## REQUEST FOR INFORMATION (RFI)

PROJECT :	BKK2	R.F.I. NO. :	523213-01-RFI-AR-0012
TO :	CTA	ATTENTION :	CTA
SUBMITTED DATE:	20-Jan-26	NEED REPLY BY DATE :	27-Jan-26

SUBJECT : Request for Confirmation - Floor Tiles Size, Start Point, Layout and Orientation for Security Room and Reception Hall 1st FL

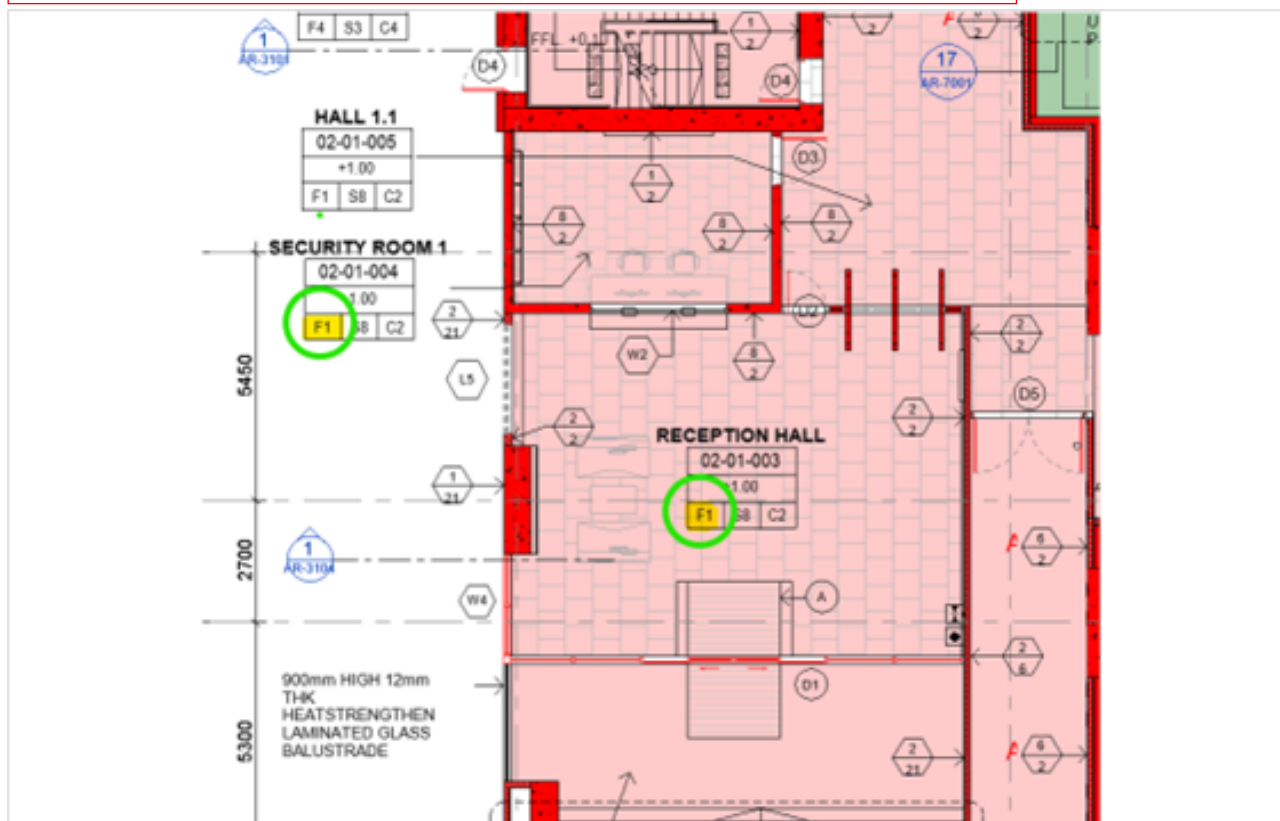
Floor Finishes F1 in ID Finishes Schedule stated 600x1200mm size floor tiles but it shows 600x600mm for reception hall in layout plan.

GC needs to follow design drawing to provide tile starting point for installation and please confirm the tile layout, orientation and size.

SLA: Floor finish F1 and tile set out point to follow ID drawing AR-4505 (see sheet 2).

DRAWING NUMBER			
523213 - 02 - DRG - AR-4505

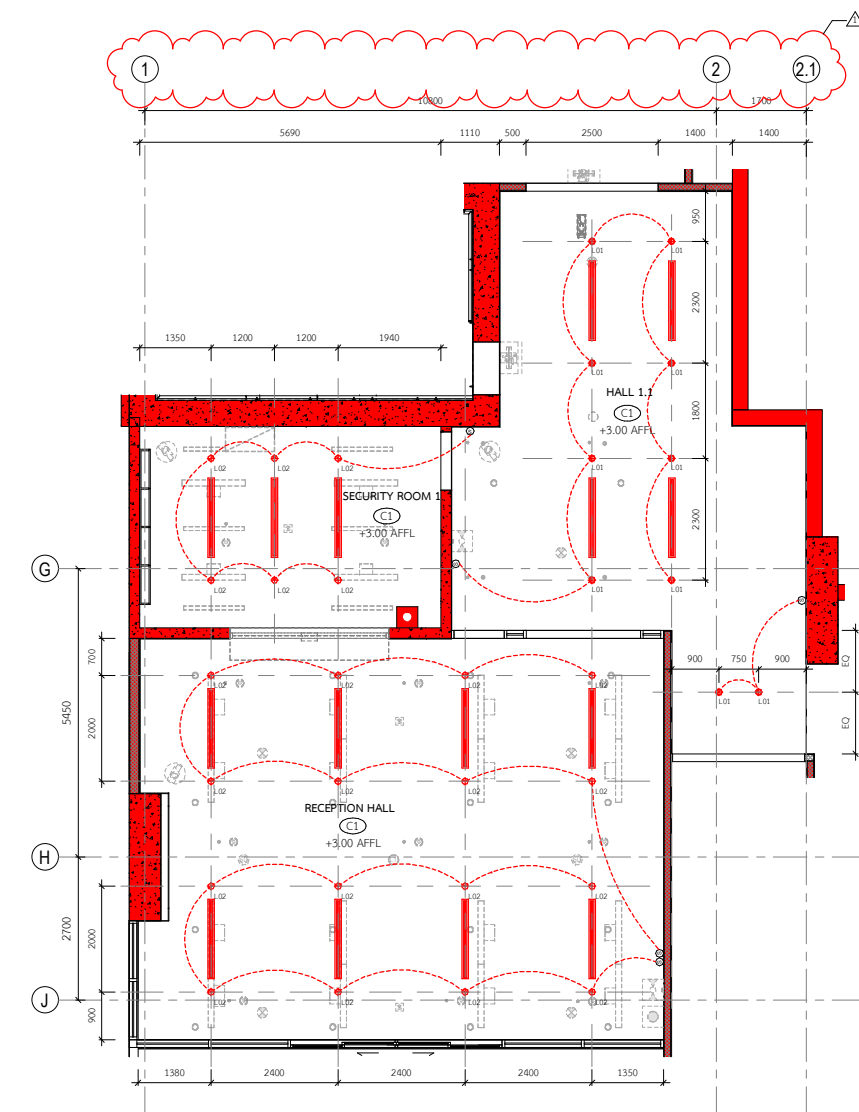
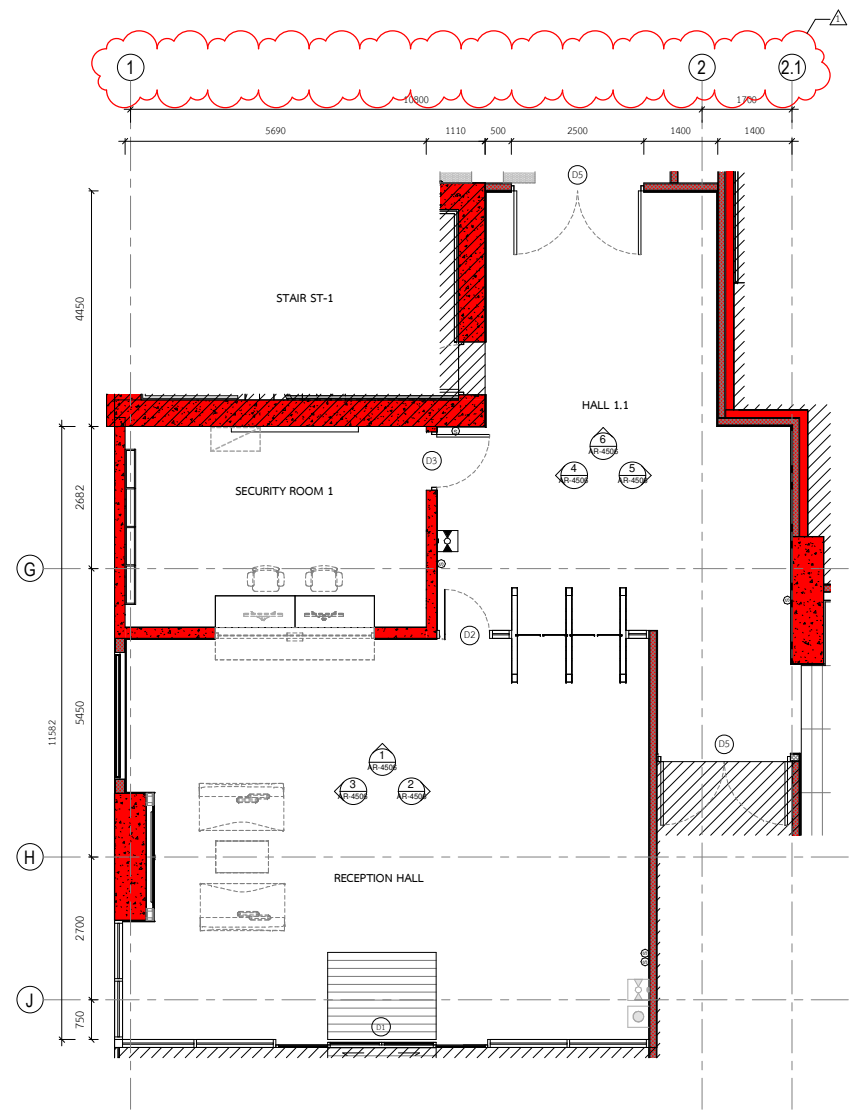
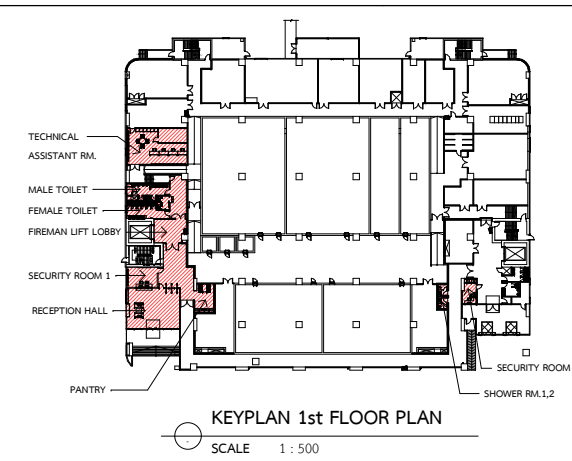
Floor Finishes F1 in ID Finishes Schedule stated 600x1200mm size floor tiles but it shows 600x600mm for reception hall in layout plan.

GC needs to follow design drawing to provide tile starting point for installation and please confirm the tile layout, orientation and size.
